PLANNING TECHNICAL REVIEW COMMITTEE –AGENDA

1. 10:30 AM – 11:15 AM: Site Review for First Street at Garrison, LLC, Assessor's Map 6, Lots 3-1 & 9, zoned CBD - General, located at First Street. (Proposal is to re-use the existing building and construct one new building, the first building with 24 two bedroom units and 8 one bedroom units also containing 1,520 sq. ft. of commercial space and 17 covered parking spaces with the second building containing 1 two bedroom units and 5 one bedroom units also with 2,412 sq. ft. of commercial space and a total of 55 proposed parking spaces on site. A CUP and LLA application will also appear before the Planning Board). (P18-25)

TECHNICAL REVIEW COMMITTEE MINUTES - P18-37

- o Change name of project **Changed to "Rivers Mark", all sheets**

SHEET 4

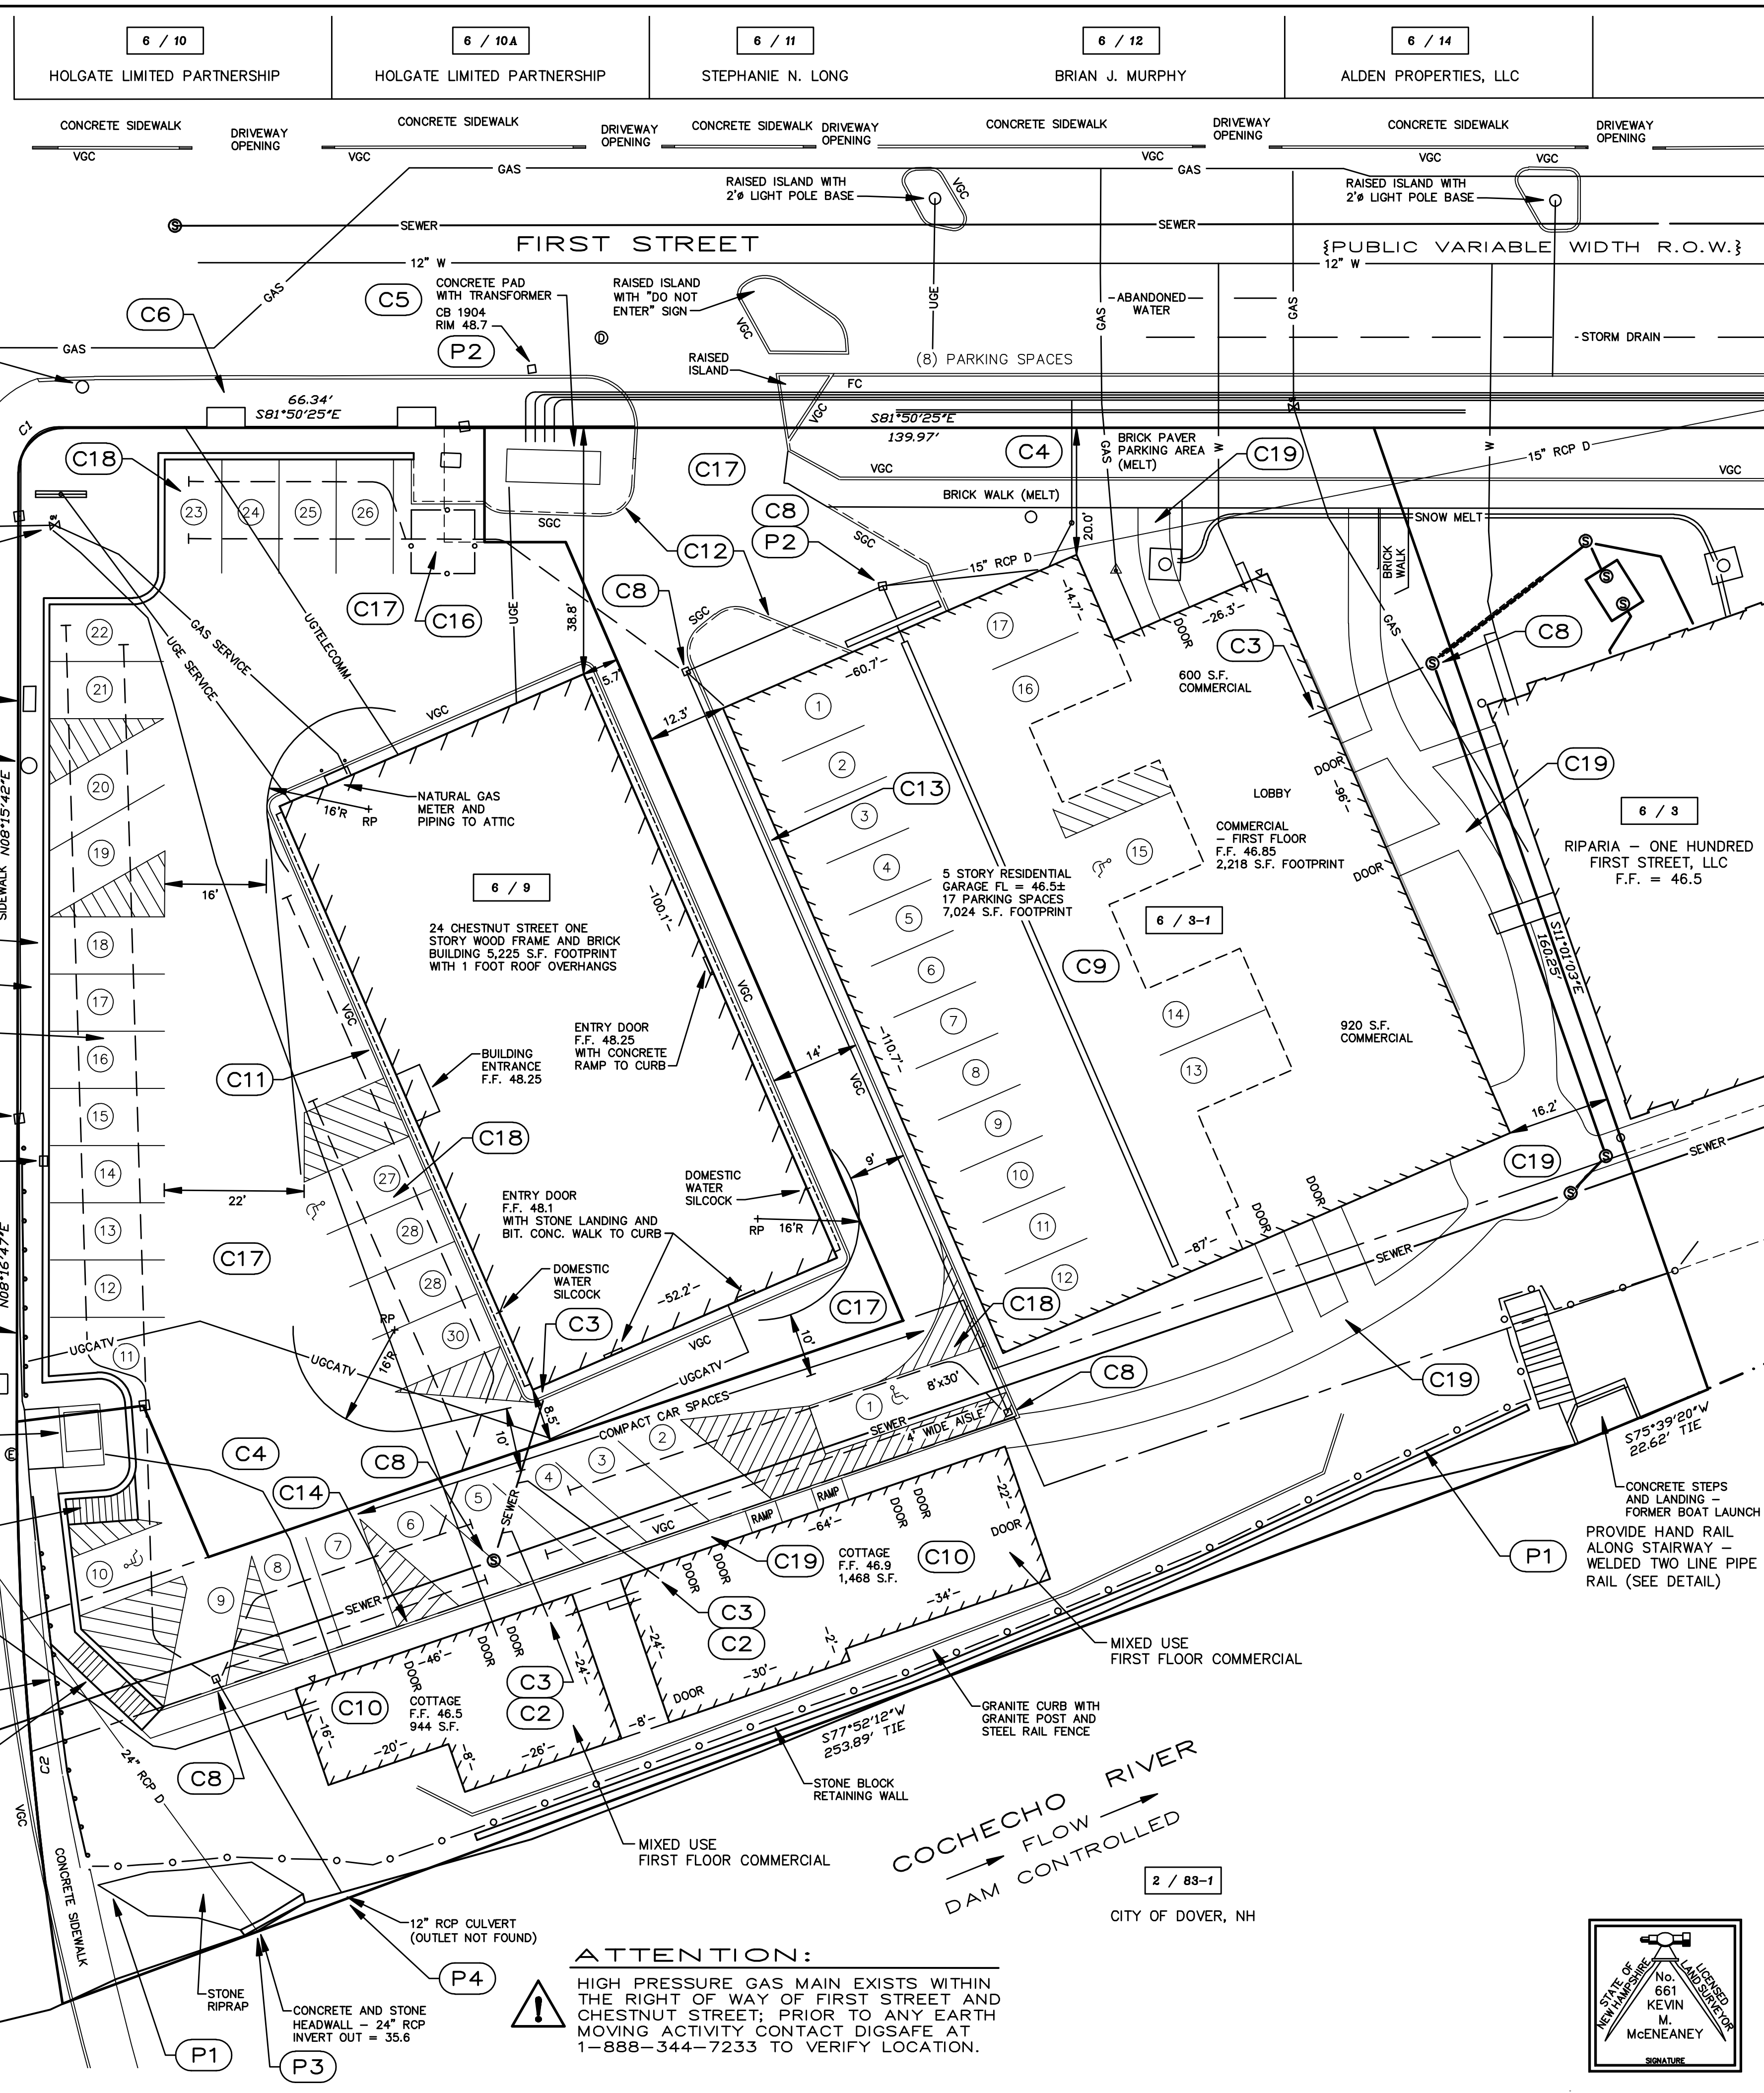
- o Indicate the location of the FDC for all buildings **Done**
 - o Identify building entrances and exits. Identify method of access to parking garage door. **Done, sheet 4**

- Indicate accessible parking spaces w/ accessible routes **Done**
- Clarify:
 - ☐ Distance from existing one structure to proposed five story adjacent structure and parcel boundaries (sheet 4) **Done**

- ☐ The 14' roadway between the adjacent structures **Yes**
 - ☐ Look at providing hand/guard rails at boat launch **Added rail at stairway note**
 - ☐ The location of generator **N/A**

- Add planning file number 18-25
- Add Rev 1 – 8/15/18 to block
- Add FF Elev 46.5 to Parcel 6/3
- Add note on plan at former boat launch to provide hand rail
- Revise P1 from silt fence to Silt Soxx
- Revise P2 from 4 places to 3 places
- Revise C3 to add remove and reconstruct Sewer Service from 24 Chestnut Street
- Revise C6 from construct curb opening to Construct Brick Paver Sidewalk per detail
- Revise C7 to include retaining wall height of 6.1 feet
- Revise C10 to include number of stories (3 ½) for mixed use buildings
- Revise plan to show additions of utilities onto site plan
- Revise plan showing elimination of two SMH's at mixed use buildings and providing for Sewer

- Revise plan to eliminate entrance from Chestnut Street
- Rename project to "Rivers Mark"
- Revise plan for parking changes
- Add 10 x 10 Dumpster pad with screening
- Add pervious paver callouts
- dd pervious walk
- Add Conc steps and railing
- Add stripe islands
- Add HC Space in Residential building
- Label curb types

- SEE SHEET 3 FOR ADDITIONAL PRELIMINARY / PRE-CONSTRUCTION SEQUENCE ITEMS.	
SHEET 5

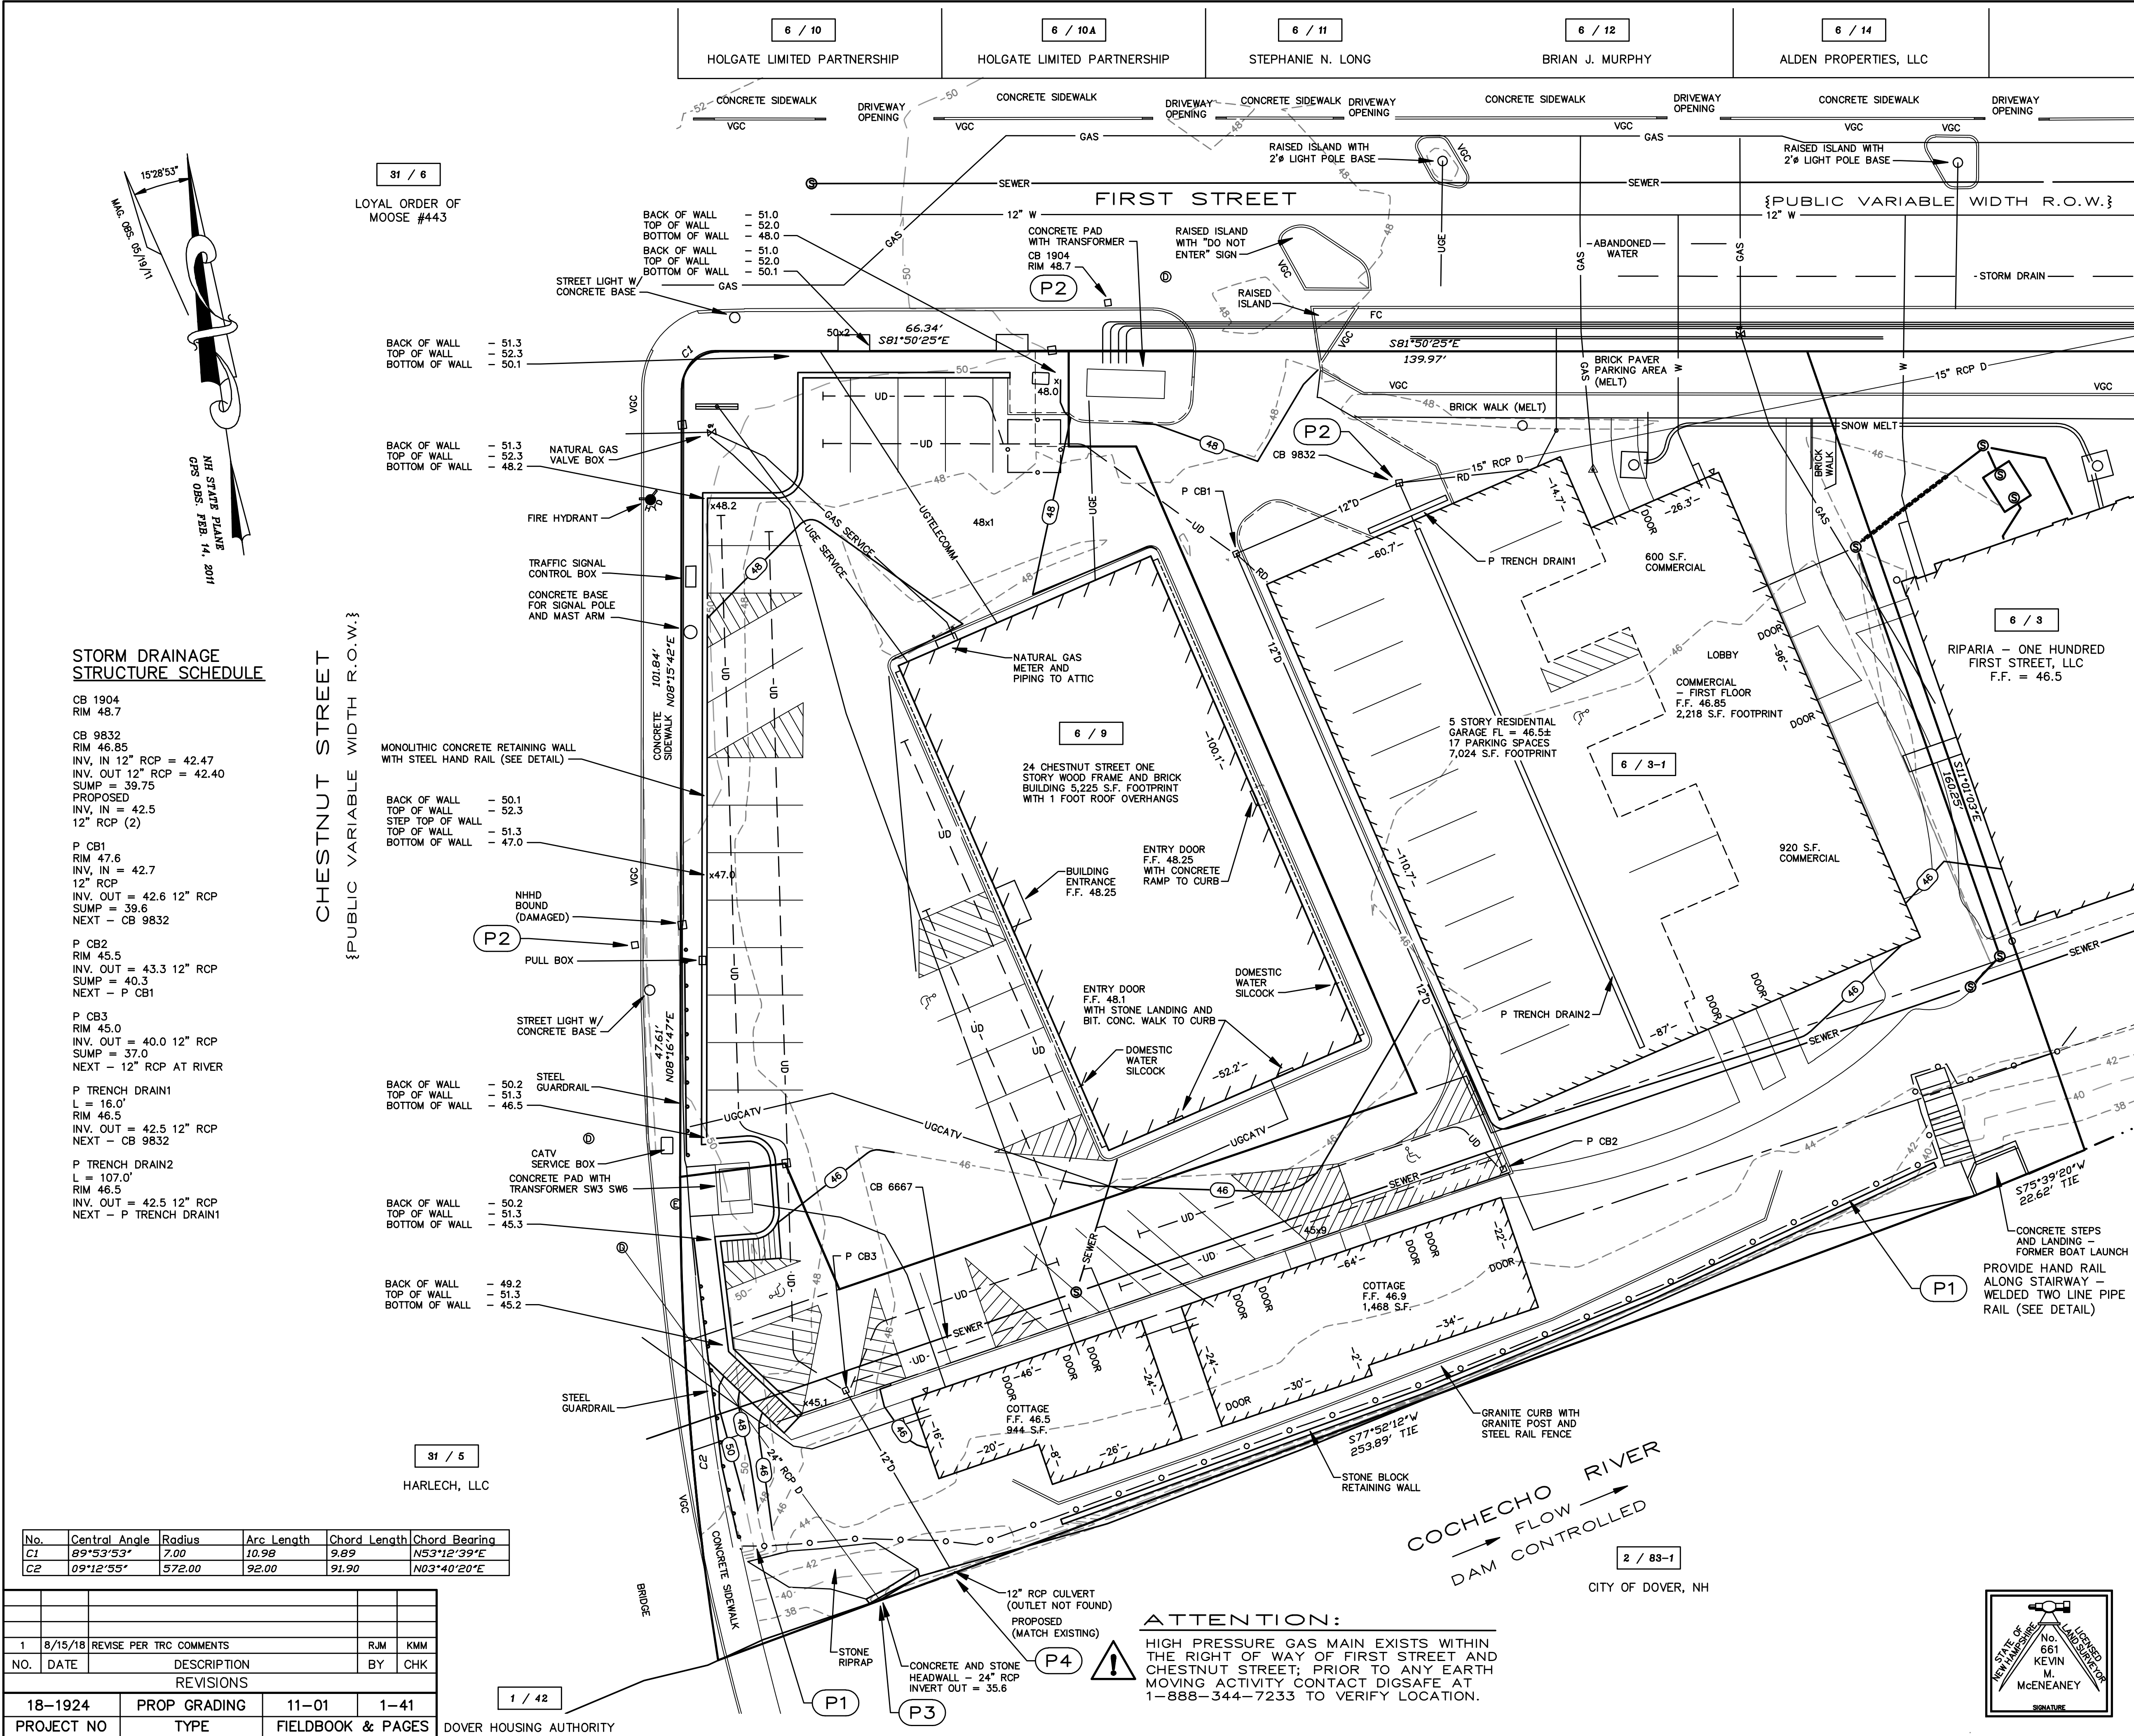
- o Include full landscape plan; note that regulations were recently amended **Landscape Architect**
- o Include drainage plan **Sheet 5**
- o Include erosion and sedimentation control plan **Sheet 3, Sheet 5**

- Add planning file number 18-25
- Add Rev 1 – 8/15/18 to block
- Add FF Elev 46.5 to Parcel 6/3
- Add note on plan at former boat launch to provide hand rail

- Add Prelim Seq list from Sheet 4
- Add mitigation and treatment table and notes
- Remove CB 6667 from chart
- Remove CB 6667 and piping to river on plan

- Add roof drains to residential building (2 places, north side)
- Add P1, P2, P3, P4 call symbols to plan
- Revise plan to show additions of utilities onto site plan

- Revise plan showing elimination of two SMH's at mixed use buildings and providing for Sewer Service Lines to same and service from 24 Chestnut
- Rename project to "Rivers Mark"

- Revise northerly wall heights
- Add door entry locations at residential building
- Revise Grading to accommodate steps to Chestnut Street
- Revise plan for parking changes

- Add Dumpster
- Add pervious paver callouts
- Add pervious walk
- Add Conc steps and railing
- Add stripe islands
- Add HC Space in Residential building
- Label curb types
